AMENDMENT OF SOLICITATION/MODIFICATION OF CONTRACT				1. CONTRACT ID CODE		PAGE OF PAGES		
2. AMENDMENT/MODIFICATION NO.			3. EFFECTIVE DATE		4. REQUISITION/PURCHASE REQ. NO.		5. PROJECT NO. (If applicable)

4. Delete Sheets G-001, P-104, M-101, M-504, M-602, MI105, and MI108 and replace with the attached Sheets G-001, P-104, M-101, M-504, M-602, MI105, and MI108.

REPAIR BEQ HP510

PROJECT NO.: 18-0042

M-101

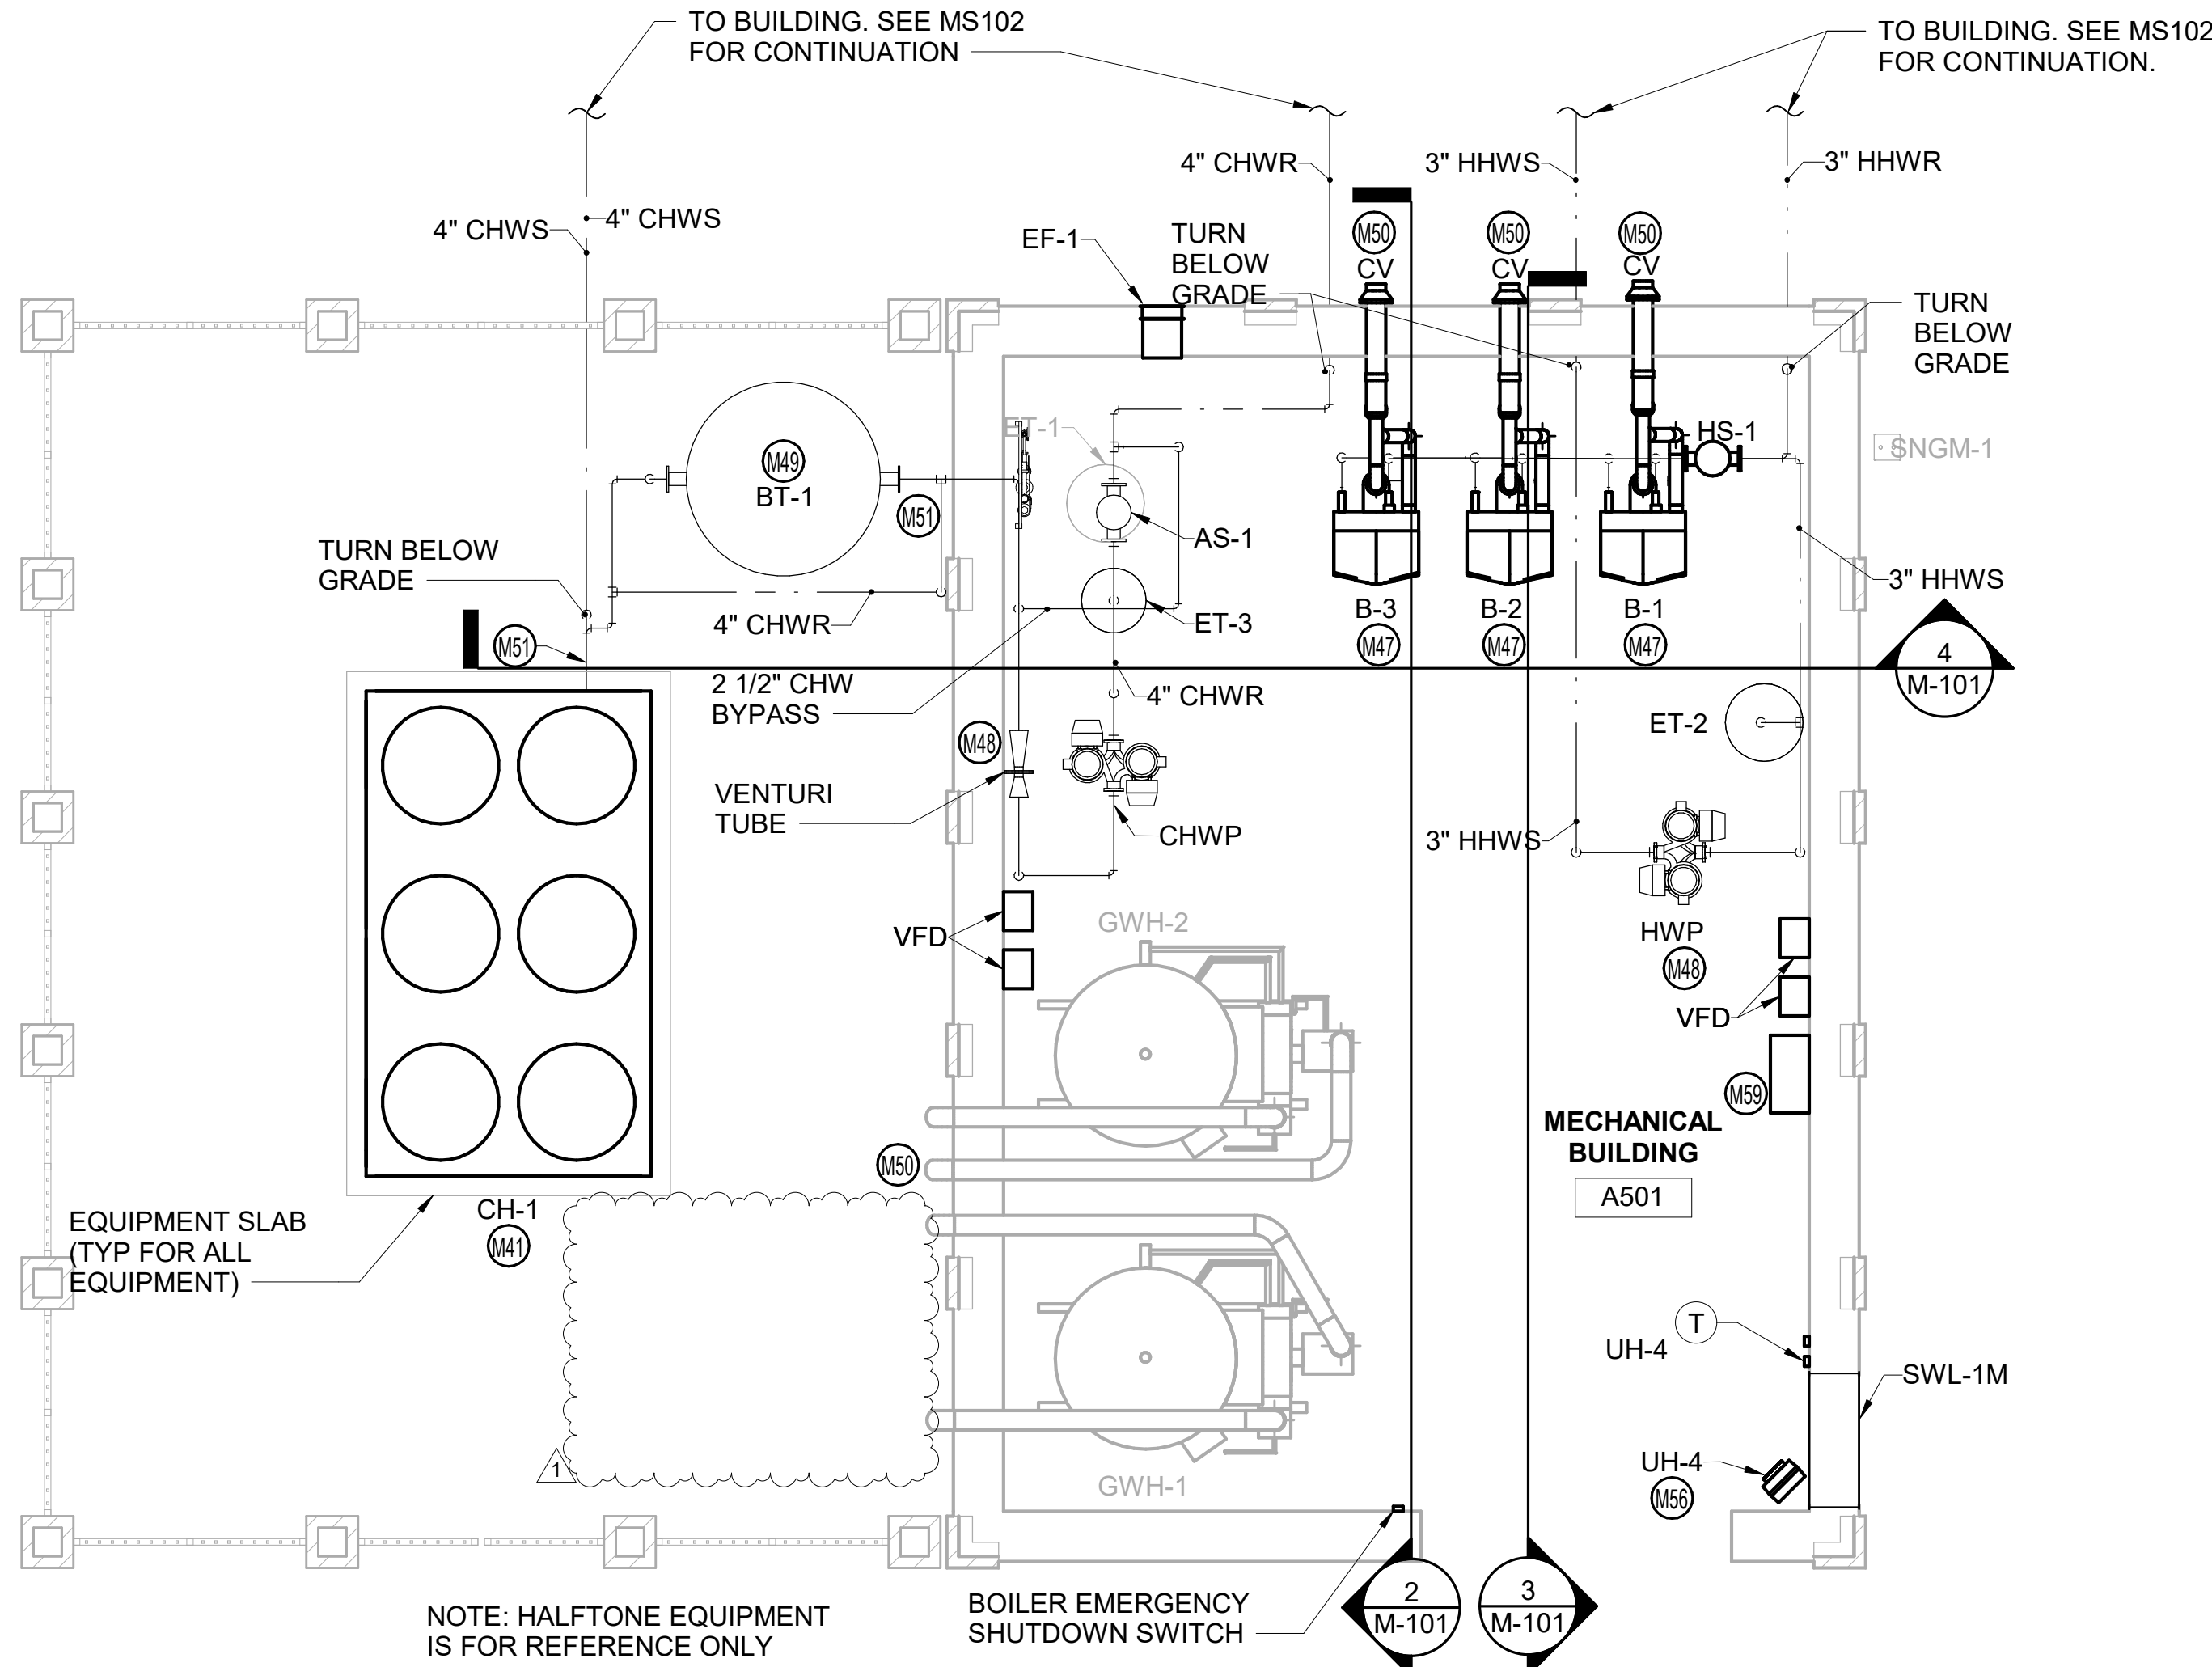
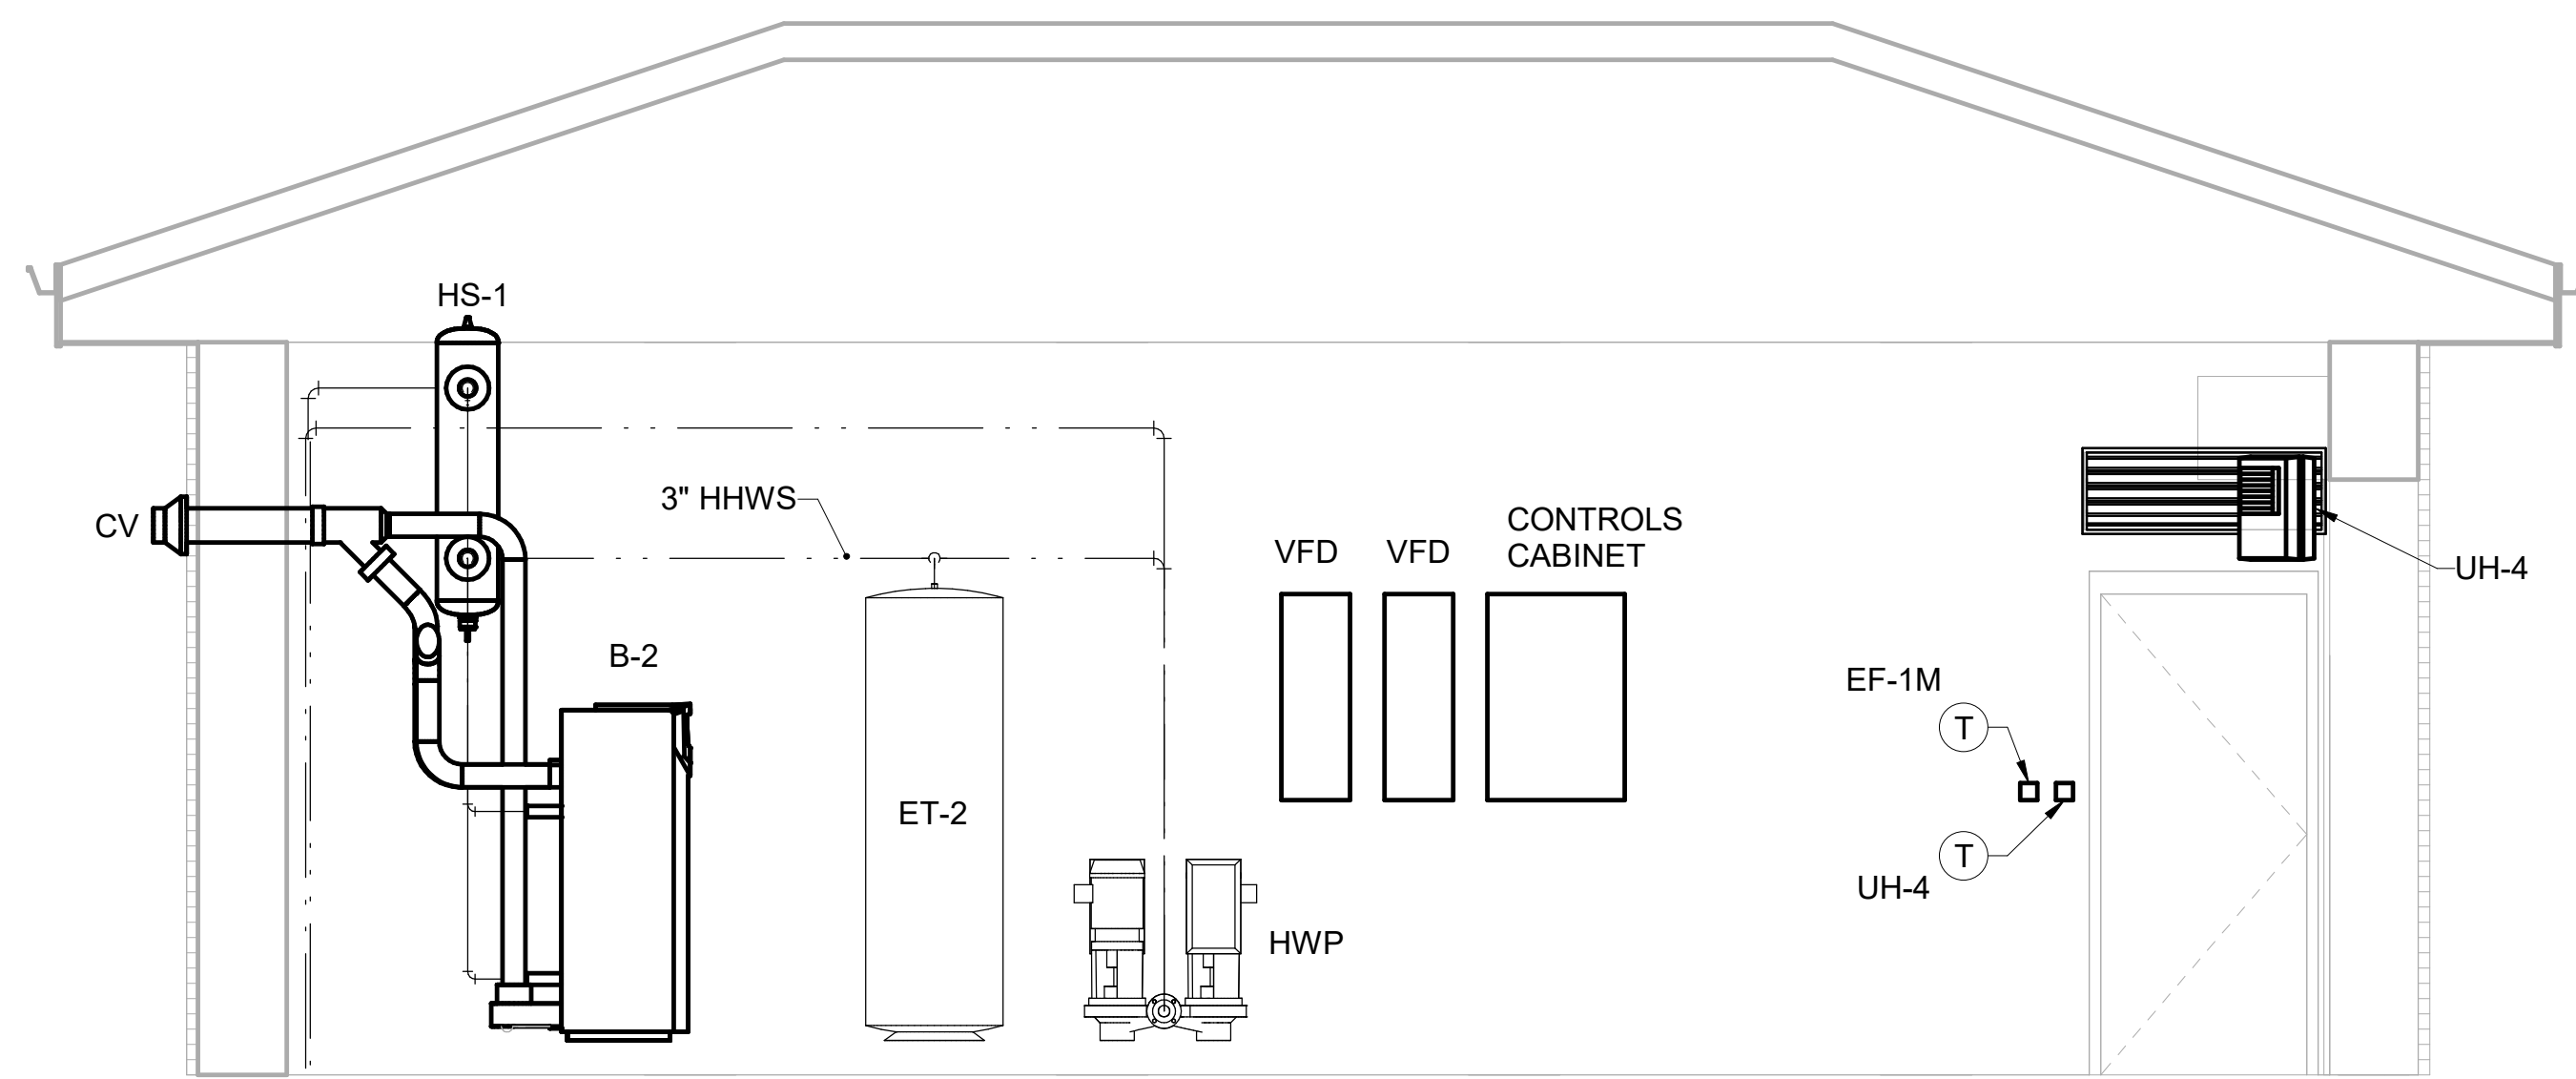
REVISIONS			
SYM.	DESCRIPTION	DATE	APPROVED
1	REMOVE ALL HEAT RECOVERY SYSTEMS	08/10/20	PCM
